RE: **Hurt Residence, Lot 11, Block 5 Unser Cliffs**  
**Grading and Drainage Plan**  
**Engineer's Stamp Date 10-1-14 (File: E10D025)**

**RE: Drainage Resubmittal  
Hurt Residence Lot 11, block 5 Unser Cliffs  
E10-D025**

**RE: Hurt Residence, Lot 11, Block 5 Unser Cliffs  
Grading and Drainage Plan  
Engineer's Stamp Date 7-7-14 (File: E10D025)**

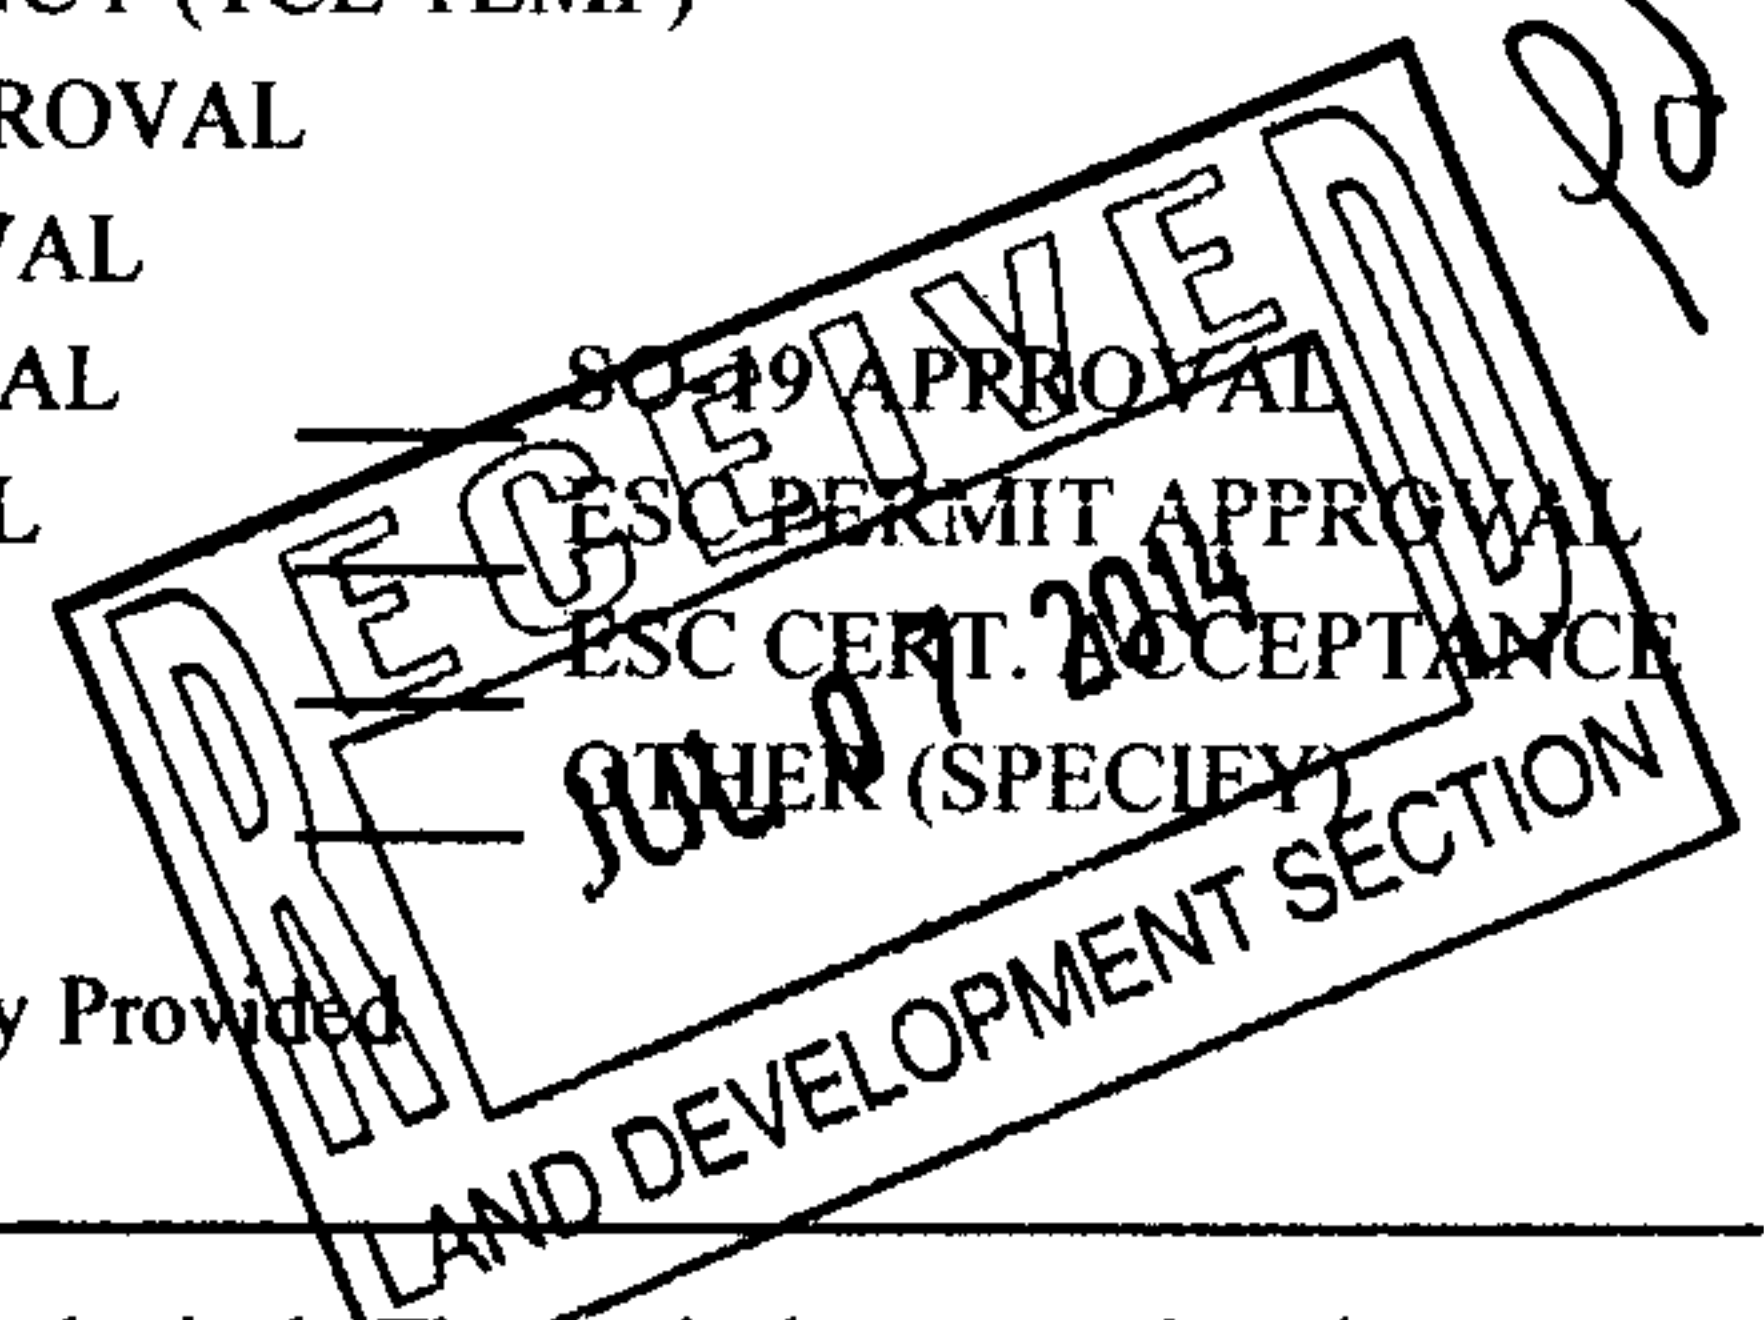
Based upon the information provided in your submittal received 7-7-14, the above referenced submittal cannot be approved for Building Permit nor for Grading Permit until the following comments are addressed.

1. Existing contours are too light too be seen
2. Indicate Zone Atlas Coordinates
3. Provide Existing and proposed drainage calculations.
4. Provide Summary or Narrative explaining drainage Scheme
5. Quantify offsite flows, if any
6. Indicate Contributing Area
7. Any easements?
8. As discussed, turned CMU Block only to occur on discharge side of property. Plan states a rundown collects runoff, and conveys to Public Storm Drain. Are there Curb cuts in Casa Blanca Cul-de-sac to convey flow to inlet? It there a rundown or a pedestrian path? Show section of rundown.
9. Consider draining to inlet at the end of Marigold with water harvesting pond in front. FL Elevations in Marigold Cul-de-sac are lower than the FP EL.
